PLANNING, ZONING, & BUILDING DEPARTMENT  
PZ&B Staff Combination Memorandum: Architectural Commission and Town Council

SUBJECT: ARC-24-022 (ZON-24-034) 726 HI MOUNT RD (COMBO)

MEETING: FEBRUARY 28, 2024, ARCOM  
MARCH 13, 2024, TC

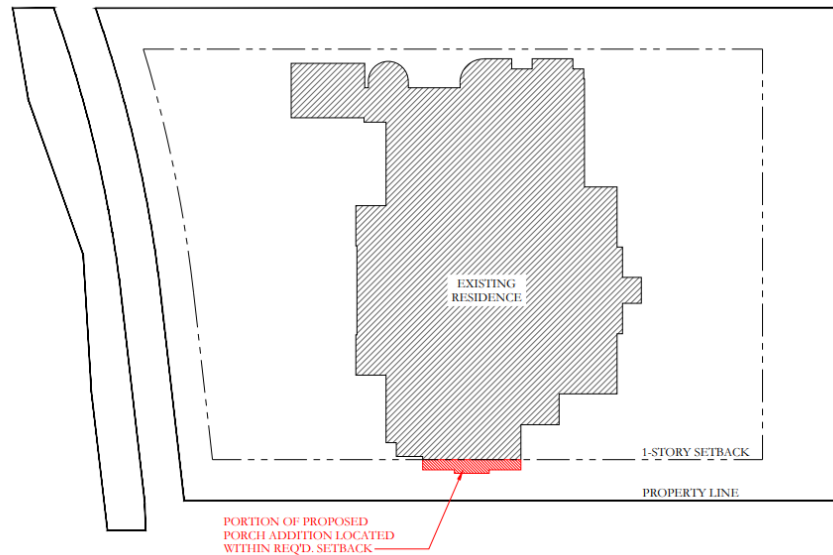
The application, as presented, requires one (1) variance for construction of the covered one-story porch addition. The applicant is proposing an 8.33' south side yard setback in lieu of the 12.5' required setback. The diagram below highlights the portion of the proposed porch addition that violates the setback requirements:

| Code Section  | Required                             | Proposed                             | Variance |
|---|--------------------------------------|--------------------------------------|----------|
| <b>Variance 1</b><br><a href="#">Sec.134-893(b)(7) (a.)</a> | One-Story Side-Yard Setback of 12.5' | One-Story Side-Yard Setback of 8.33' | 4.17'    |
